**LOCAL LAWS
OF
THE CITY OF NEW YORK
FOR THE YEAR 2016**

No. 91

To amend the administrative code of the city of New York, in relation to conforming the New York city energy conservation code to the New York state energy code with amendments unique to construction in the city and repealing section 28-1001.2 in relation thereto

FIGURE C405.2.3.2(1)
DAYLIGHT ZONE ADJACENT TO FENESTRATION IN A WALL

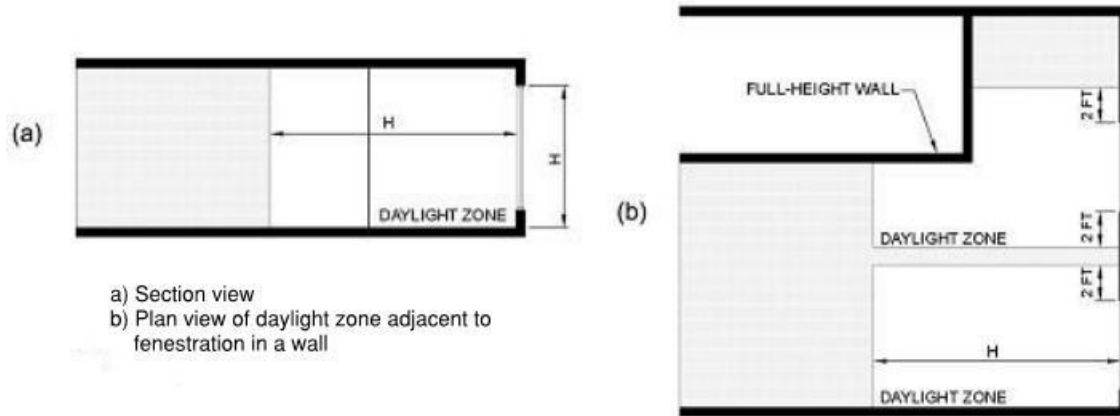
Figure C405.2.3.2(1)(b) - Delete Figure C405.2.3.2(1)(b) in its entirety and replace with a new Figure C405.2.3.2(1)(b) to read as follows:

FIGURE C405.2.3.2(3)
DAYLIGHT ZONE UNDER A SLOPED ROOFTOP MONITOR

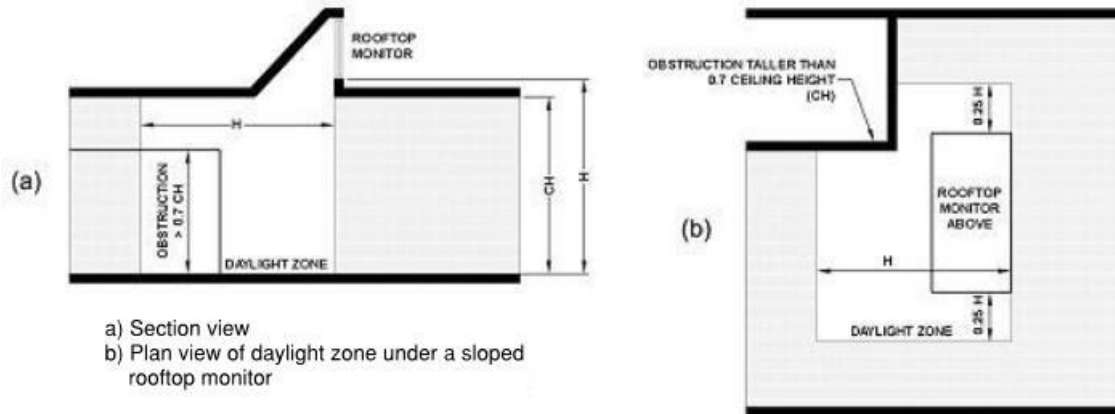
Figure C405.2.3.2(3)(b) - Delete Figure C405.2.3.2(3)(b) in its entirety and replace with a new Figure C405.2.3.2(3)(b) to read as follows:
